The Houston Housing Authority (HHA), has issued this Amendment No. 2 to IFB 23 – 48 Replacement of Roofs @ Bellerive Senior Living Apartments for the purposes of,

Figure 1

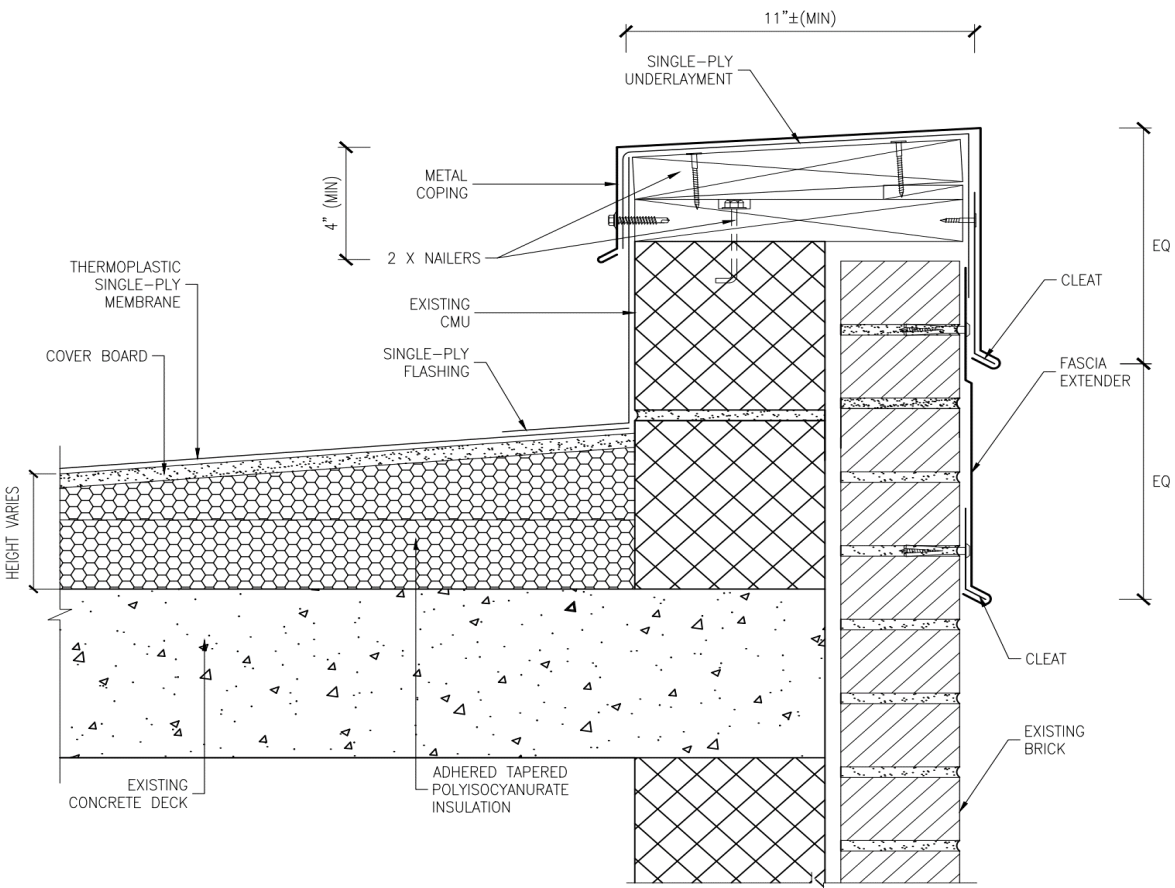
Question 12: The existing parapet wall configuration do not match the roof detail 1/R5.01 – the existing wall width is 4.5” and only 9” high +- from the top of the existing concrete deck the entire perimeter wall. – can we keep the components of the existing wall configuration? (See Figure 1 and 2)

Answer 12: The width of the existing parapet walls vary from 4”/5” +/- to 11”+/-.

Figure 4

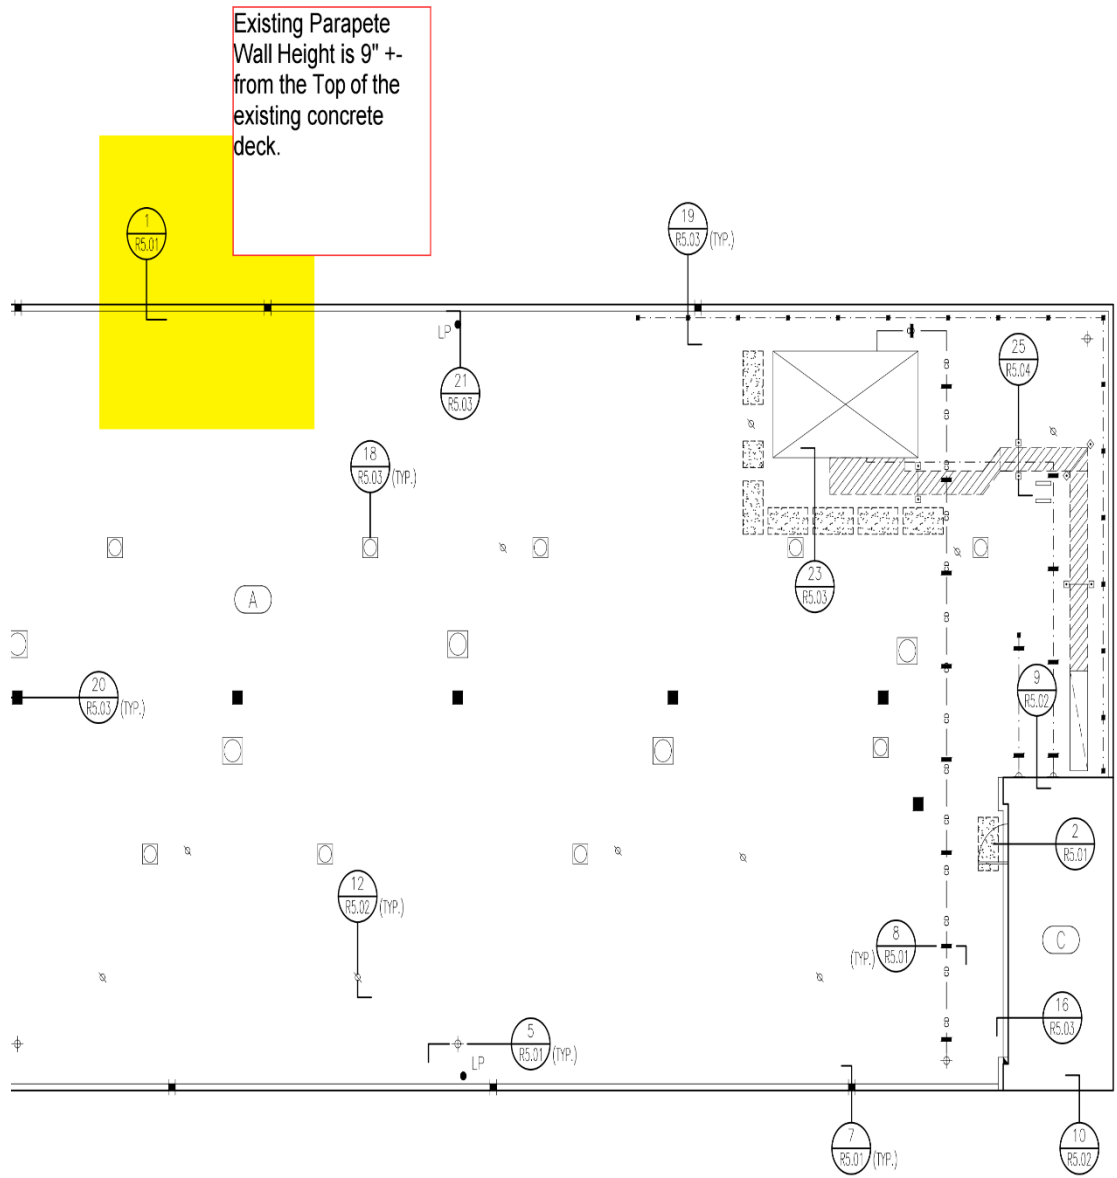
Question 9a: There are power vents whose covers are damaged but to make the replacement you have to replace the entire power vent. Please note images attached. The question is: Is complete replacement allowed? (See Figure 4 and 5)

Answer 9a: It is the intention that the power vent hood is removed and reinstalled to facilitate the new roof installation.
